**TOWN OF LEESBURG
TOWN COUNCIL PUBLIC HEARING**

Subject: Rezoning Application TLZM-2013-0006, Crescent Parke

Staff Contact: Michael Watkins, Assistant Zoning Administrator, Department of Planning and Zoning

Figure 1. Park Property

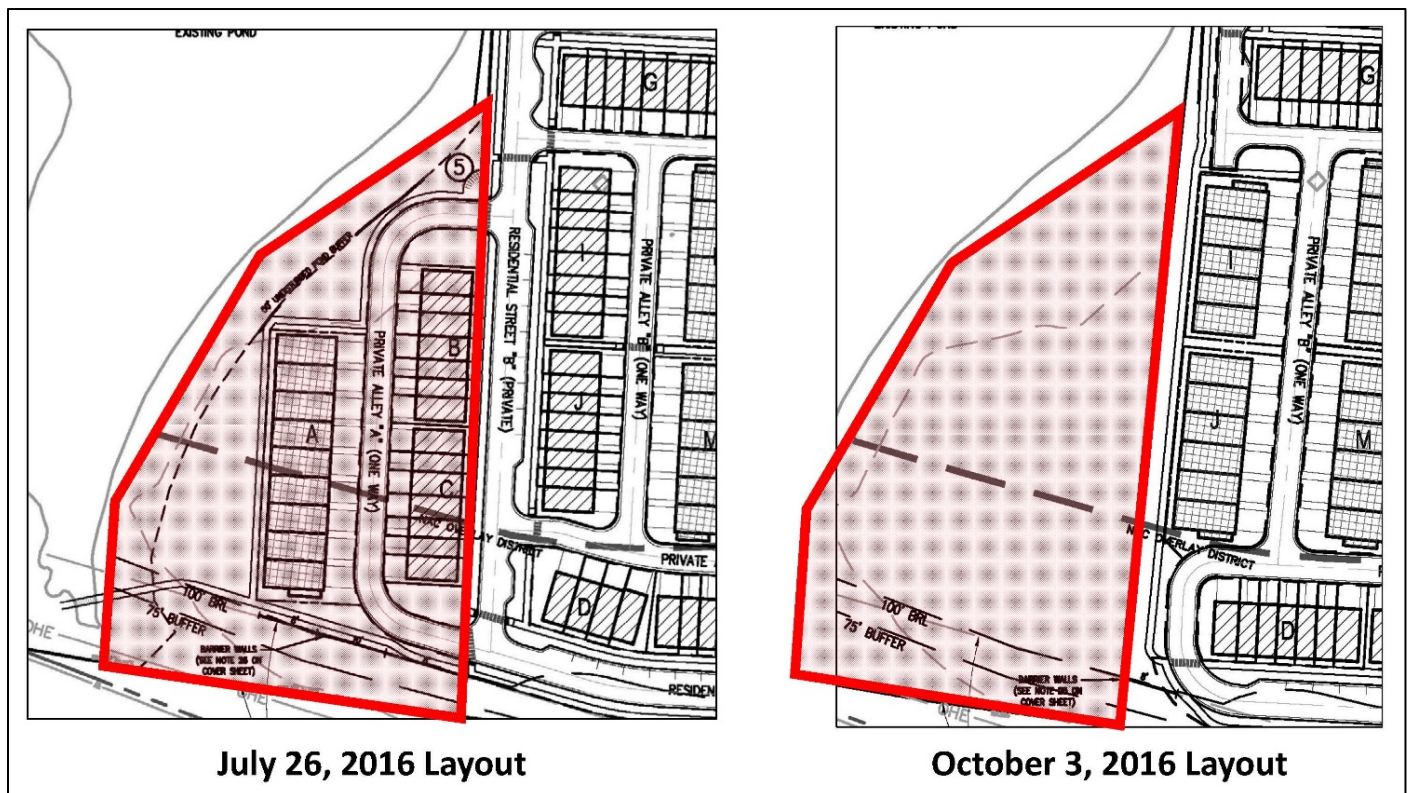
- Limits of the application: The Applicant has eliminated the 2.3 acre portion of the Olde Izaak Walton Park Property (OIWP). Figure 1 illustrates the removal of 14 town houses and 18 stacked town houses.

Figure 2. Revised C2-4 Building Layout

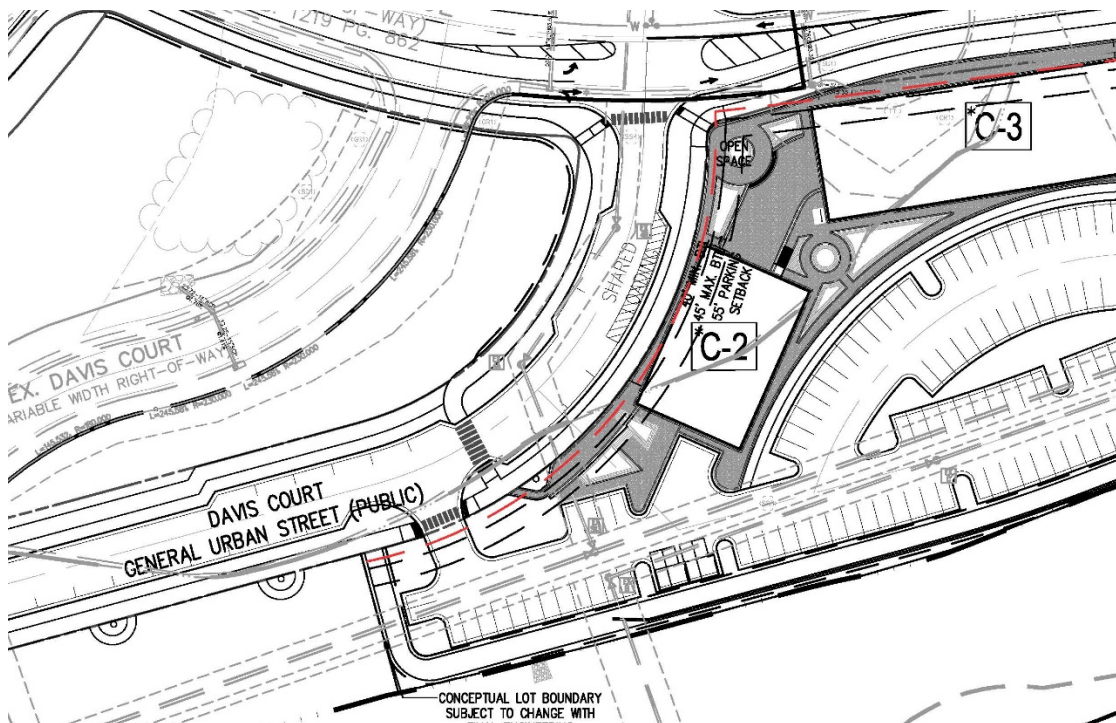
- Frontage Calculation: The Concept Plan was revised to provide the necessary building frontage along Davis Court. As part of this revision, the entrance to

Buildings C2 thru C4 was relocated further west providing a more logical connection to the adjacent property. A modification of the frontage requirement is requested to reduce the required 66% to no less than 50%. Tabulations on Sheet 2B demonstrate that at least 50% of the street frontage is occupied by buildings. The frontage reduction is approvable if Council finds that the resulting open space complements the overall design of the project. The open spaces are designed to include landscaping areas, hardscape (seat walls), and opportunities for public art.

Analysis: Staff does not object to the approval of the zoning modification. Design recommendations are included in subsequent comments.

Figure 3. MU Building Layout

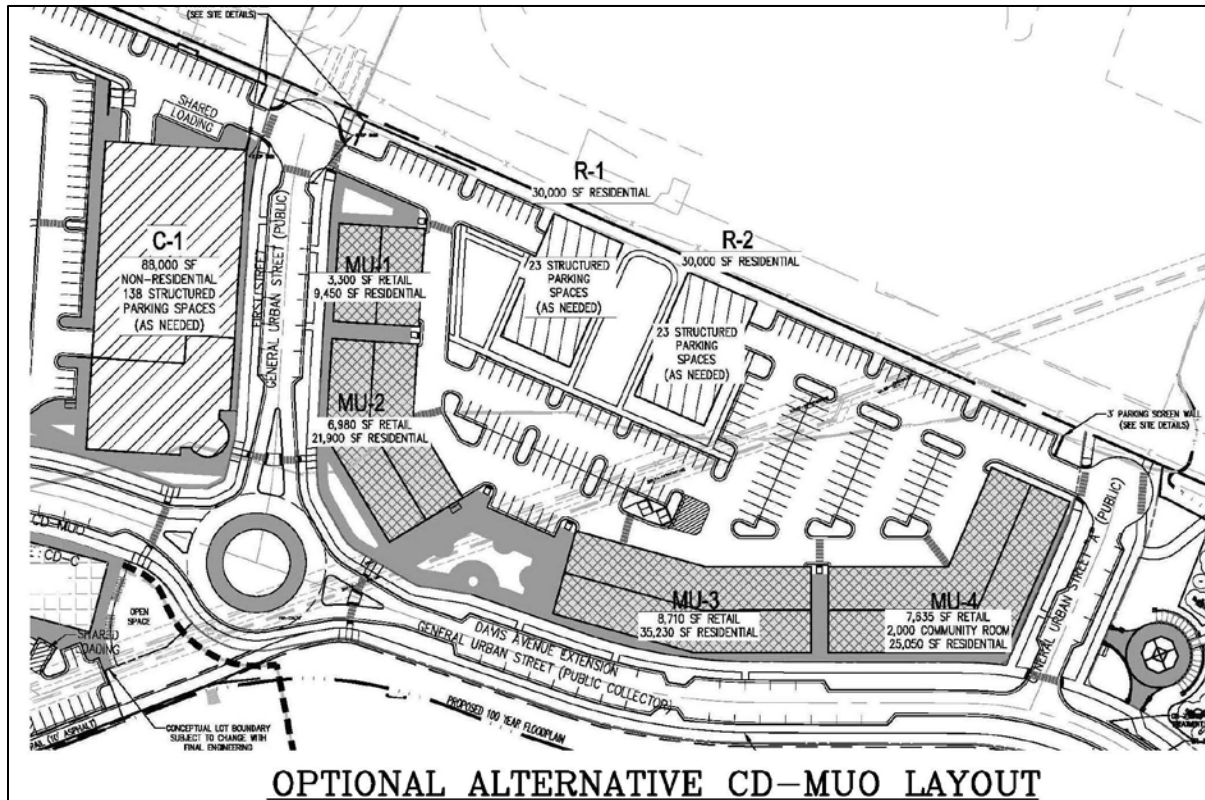
- iii. Alternate MU Buildings, Layout: The Applicant was previously notified that alternative layouts are recommended; however, sufficient information should be provided to detail conformance with zoning requirements and intended design. The area behind Buildings MU1 thru MU4 includes an alternative layout for two additional buildings. The application has NOT included a landscaping plan for the alternative layout.

- iv. Alternate MU Buildings, Parking: The area behind Buildings MU1 thru MU4 includes an alternative layout for two additional buildings. These buildings occupy an area that provided surface parking for the MU buildings. The Concept Plan has not been revised to provide a calculation of required parking that reflects the loss of the surface parking and addition of two buildings.

Analysis: The application should be revised to provide a landscaping plan. If Council wishes to approve this application, staff recommends that an additional proffer be provided to require the Applicant to work with staff to provide an appropriate landscaping plan for the alternative

layout. The proffer should include language that prohibits the submission of any site plan until such time as the additional landscaping plan is approved by staff. Staff will draft language for the Applicant and Council to consider at the public hearing.

Analysis: The Concept Plan must be revised to provide a parking calculation that demonstrates compliance with required parking standards.

Figure 4. Revised CD-RH Layout

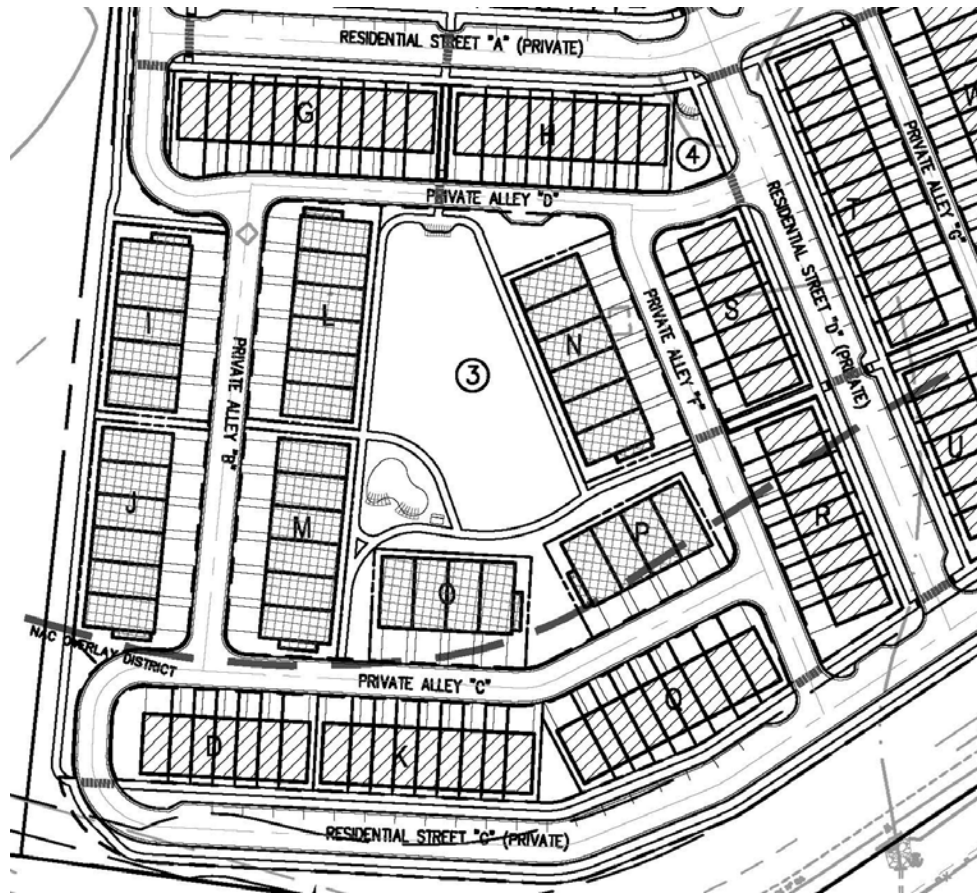
- v. Revised Residential Layout: The area adjacent to the Olde Izaak Walton Park Property was previously revised to eliminate area of the park property from the rezoning application. The removal of this part of the application resulted in changes to the layout. The revised layout effects access to Buildings G, I, J, and D, see Figure 4 below. Staff does not prefer the layout due to the

circuitous nature of the access to the referenced buildings. In addition, a Design and Construction Standards Manual modification is necessary due to the tight radii of the turns and potential constraints for emergency access. The modification has been submitted to staff and referred to the Fire Marshal's Office, but a recommendation from the Fire Marshal has not yet been received.

Analysis: The Applicant is moving forward at their own risk without feedback from the Fire Marshal's office. It would appear, based on the criteria the Fire Marshal's Office is requiring, that the Applicant has provided the necessary plan revisions for a conditional approval, subject to final engineering requirements.

Figure 5. Alternate Park Access

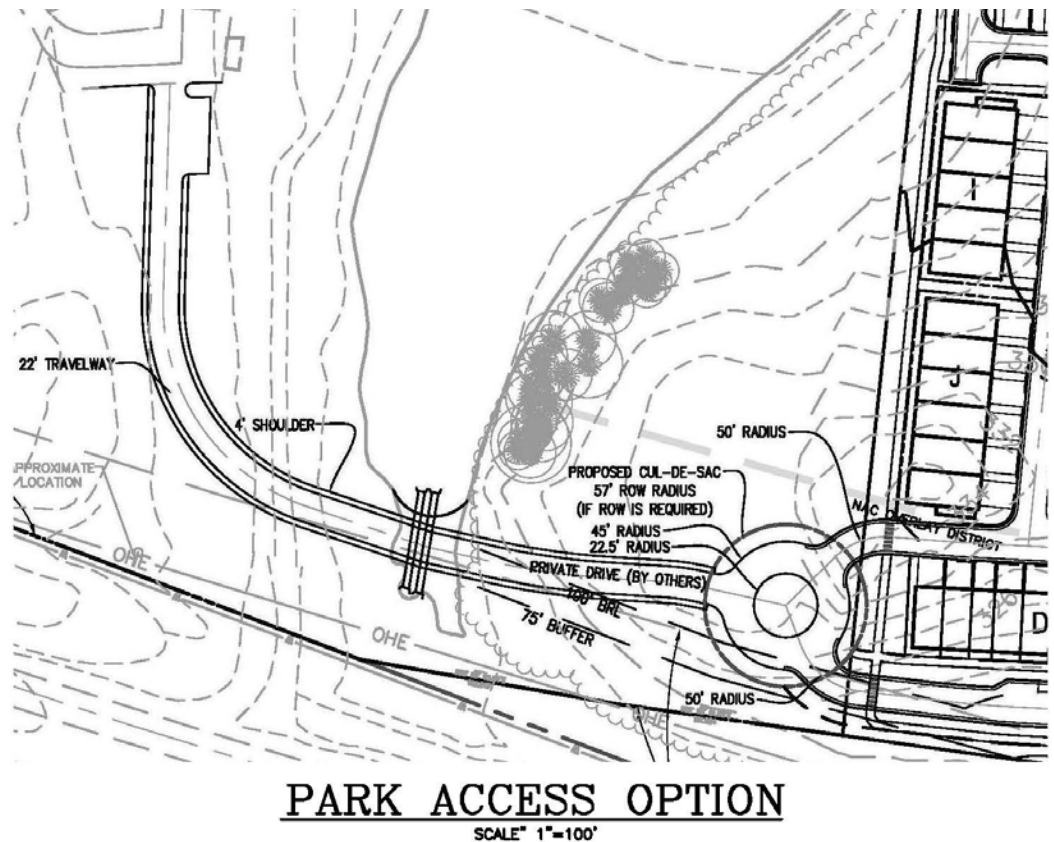
- vi. Park Access: In an effort to reduce costs associated with the Davis Court bridge rehabilitation, staff introduced the idea of providing access to Olde Izaak Walton Park from the Crescent Parke Property. The existing David Court Bridge provides access; however it is old and cannot support the weight of large vehicles, particularly emergency vehicles. Replacement of the bridge

has been identified in the Town Capital Improvement Plan; however, the costs associated with replacement could exceed one-million dollars due to structural rehabilitation and relocation outside of the 100-year flood plain in addition to design floodplain analysis costs.

The proposed access would be provided via an extension of a public road. See Figure 5. The Davis Court Bridge can remain in place as a pedestrian connection to the park. The bridge would only require minor modifications for pedestrian safety. Davis Court would then be terminated in a cul-de-sac.

Analysis: This option eliminates the need and cost associated with rehabilitating the Davis Court Bridge and provides a safer access to the Olde Izaak Walton Park Property.

Figure 6. Amenity Area

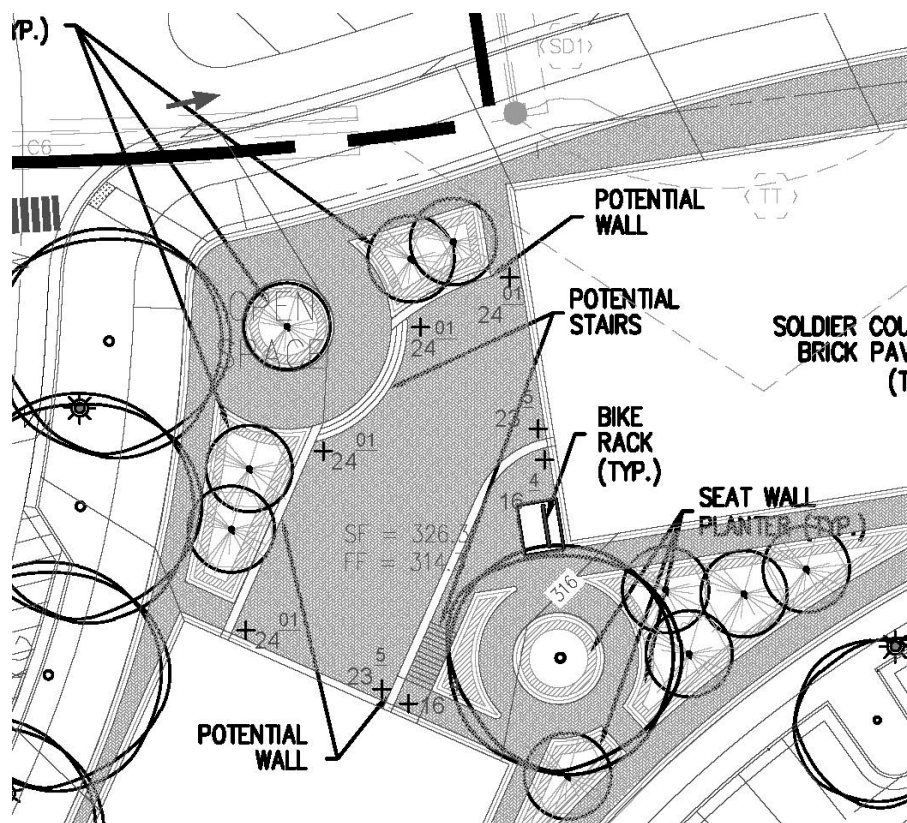
- xi. Amenity Area, Retaining Walls: There are several references to retaining walls within the amenity area, some as tall as seven (7) feet.

Analysis: Staff requests a proffer be added that requires ornamentation of retaining walls to create visual interest. The proffer should specify that materials and design shall be approved by staff prior to the approval of any site plan.

Analysis: Staff recommends that the design of Pocket Park 11 include a vegetative buffer five (5) feet wide to soften the hardscaping and provide a safety measure given the height of the adjacent retaining wall.

Figure 7. Roundabout

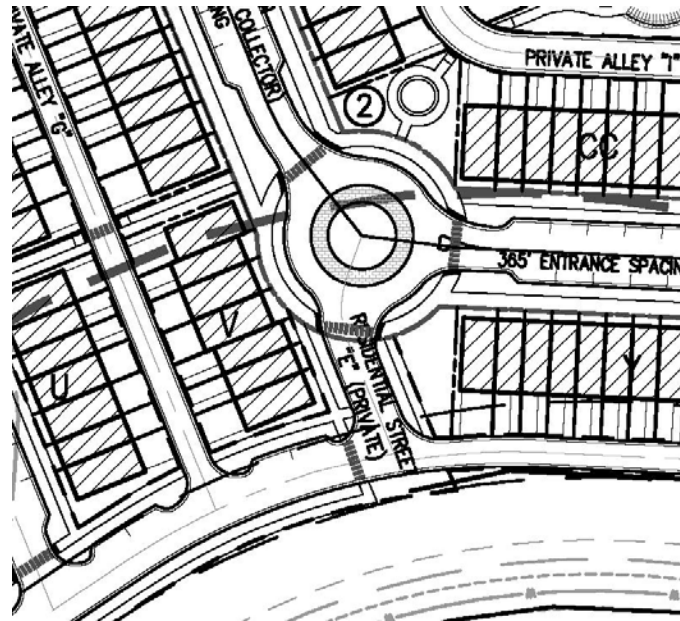
- xiii. Intersection Separation: An engineering issue which may affect the layout is the separation of the roundabout to Residential Street A. Residential Street A was planned to be private and the intersection separation did not apply. With the proposed access to the park, Street A becomes public and VDOT intersection separation requirements apply.

The Applicant is working on an engineering solution to be presented at the public hearing.
